**CERTIFICATE OF APPROPRIATENESS**

**Property:** 7715 Morley Street, Lot 17, Block 51, Glenbrook Valley Section 9 Subdivision. The property includes a historic 2,181 square foot, one-story wood frame single-family residence and attached garage situated on a 9,660 square foot (70' x 135') interior lot.

**Proposal:** Alteration – Windows. Replace all 17 original aluminum windows with 13 vinyl 1-over-1 and horizontal slider windows. The new windows will result in changing the original fenestration pattern of the home. Staff performed a site visit and no damage was noted on any of the windows. See enclosed application materials and detailed project description on p. 5-11 for further details.

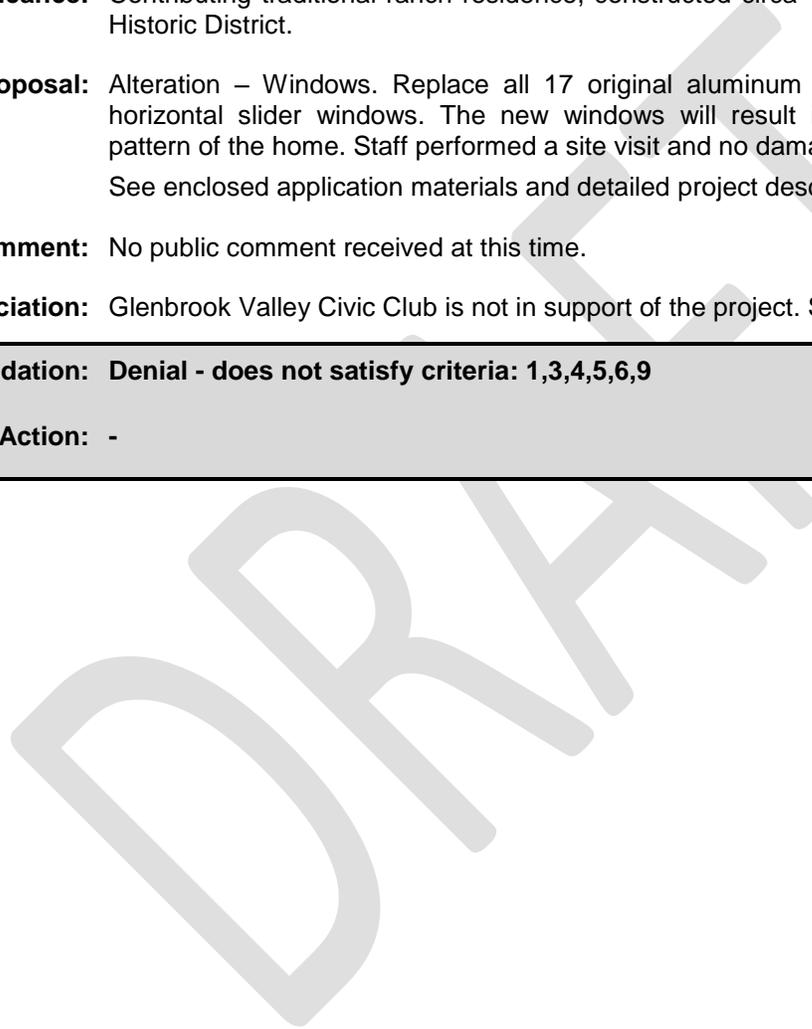
**Recommendation:** Denial - does not satisfy criteria: 1,3,4,5,6,9
